ARTICLE 14. ONE AND TWO FAMILY DWELLING CODE

Rule 2.1. CABO One and Two Family Dwelling Code; Amendments

FIGURE R502.8
CUTTING, NOTCHING AND DRILLING

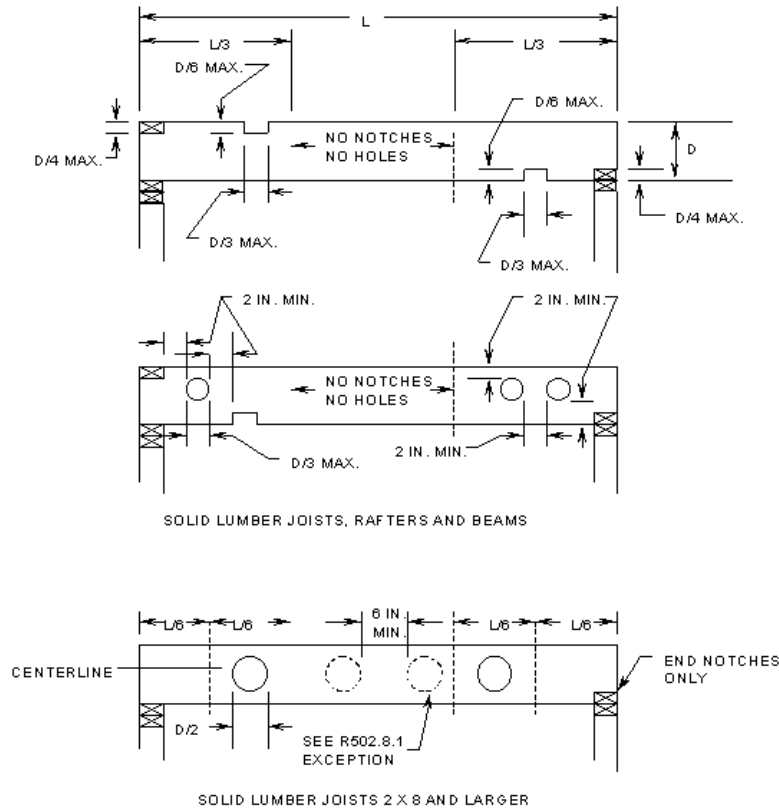
Sec. 88. Delete FIGURE R502.8 and substitute as follows: FIGURE R502.8:

FIGURE R602.6(2)
NOTCHING AND BORED HOLE LIMITATIONS FOR INTERIOR NONBEARING WALLS

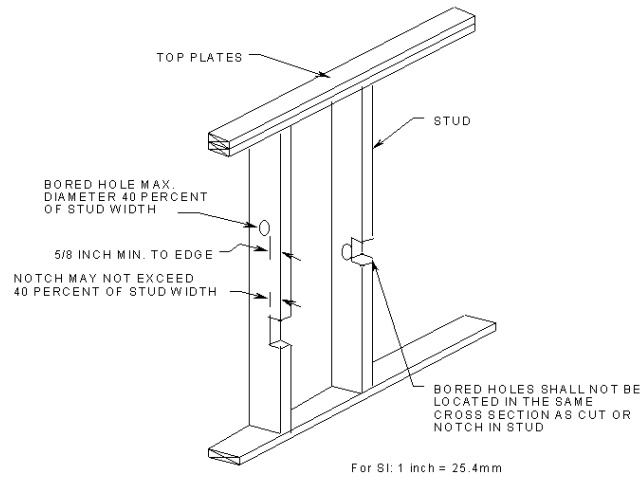
Sec. 95. Delete FIGURE R602.6(2) and insert FIGURE R602.6(2) to read as follows:

FIGURE R602.10.5(2)
GARAGE DOOR BRACED WALL PANEL FOR USE WITH CONTINUOUSLY SHEATHED WALLS

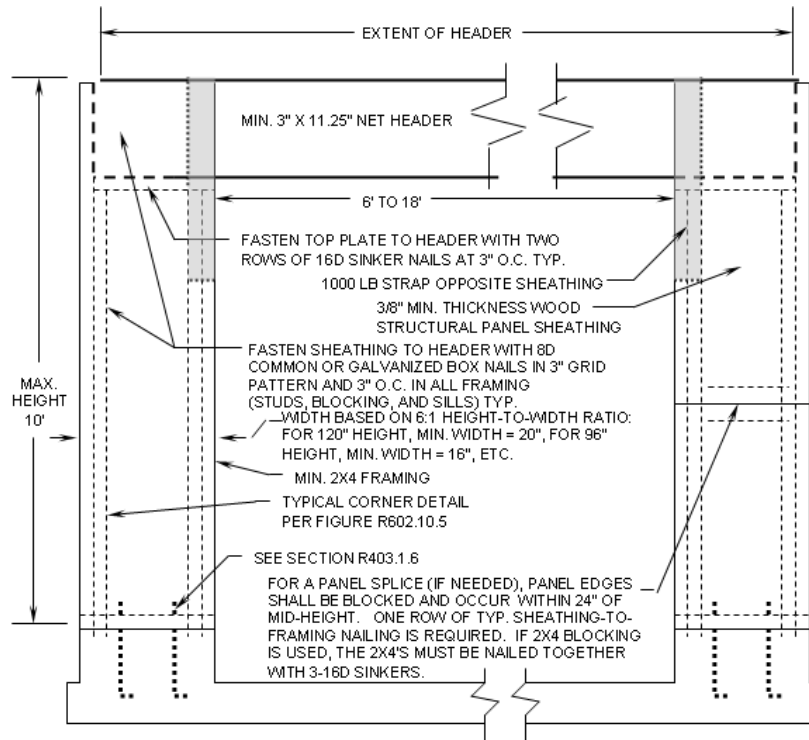
(4) Add FIGURE R602.10.5(2) to read as follows:

FIGURE R703.7.6(1)

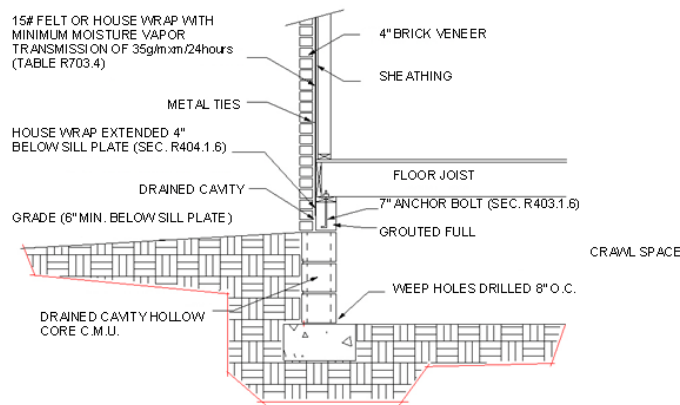
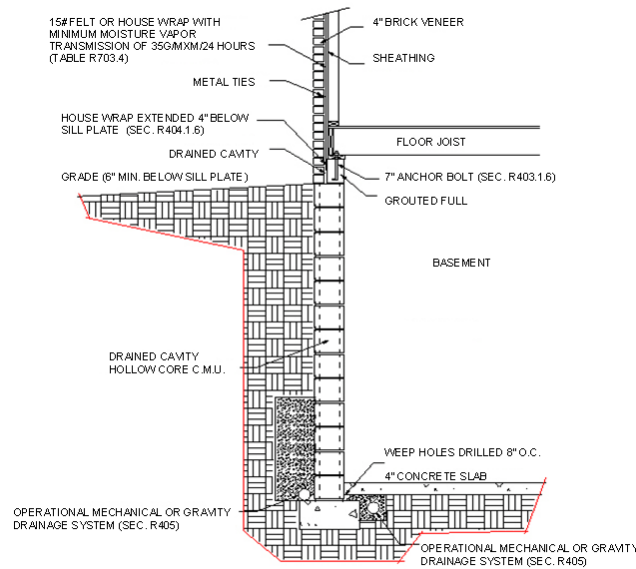
Sec. 121. Delete the title and text of SECTION R703.7.6 and substitute as follows: R703.7.6 Drained cavity. The 3/4 inch (19 mm) air cavity shall be drained to the exterior of the structure at intervals of not more than 33 inches (838 mm) on center. Each drain shall be not less than 3/16 inch (4.8 mm) in diameter, located immediately above the flashing. For dwellings with crawl spaces, the air cavity may be drained as shown in FIGURE R703.7.6(1). For dwellings with basements, the air cavity may be drained as shown in FIGURE R703.7.6(2).

FIGURE R1001.6
Chimney Termination

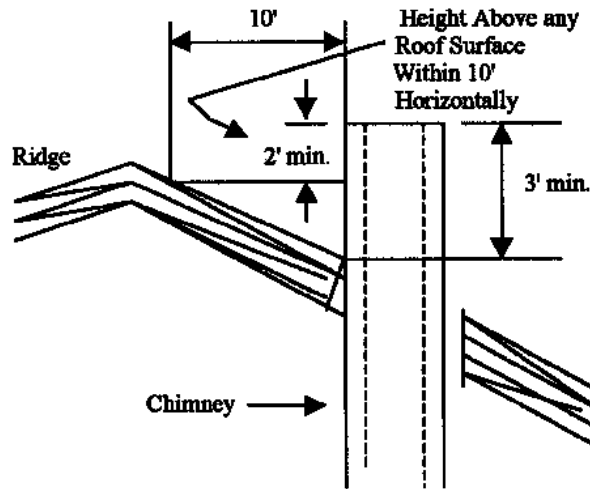
Sec. 135. Add FIGURE R1001.6 as follows:

FIGURE E3801.4.1

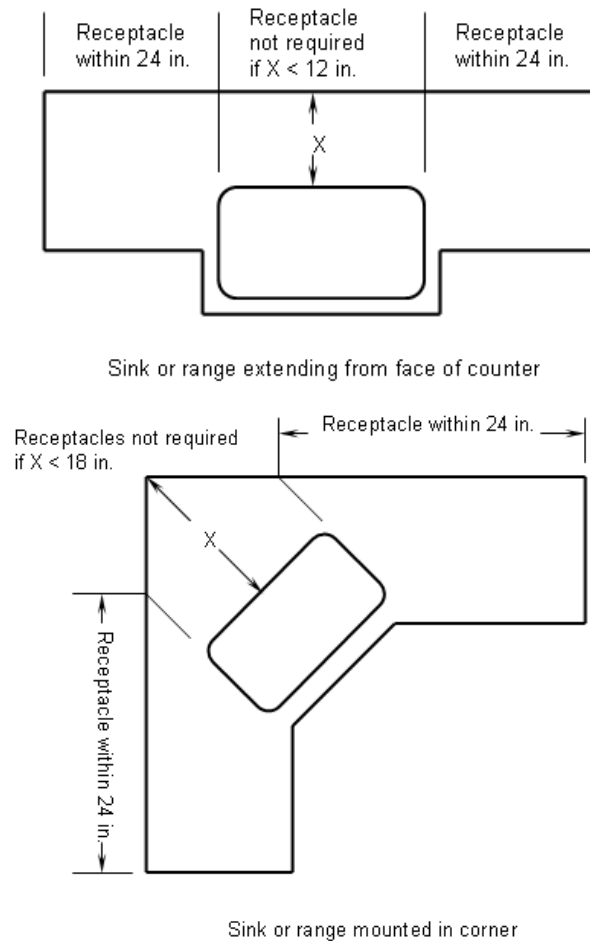
Sec. 229.5. (a) After SECTION E3801.4.1, add an exception to read as follows: Exception: Receptacle outlets shall not be required on a wall directly behind a range or sink in the installation described in FIGURE E3801.4.1.

(b) After SECTION E3801.4.1, add FIGURE E3801.4.1 as follows:
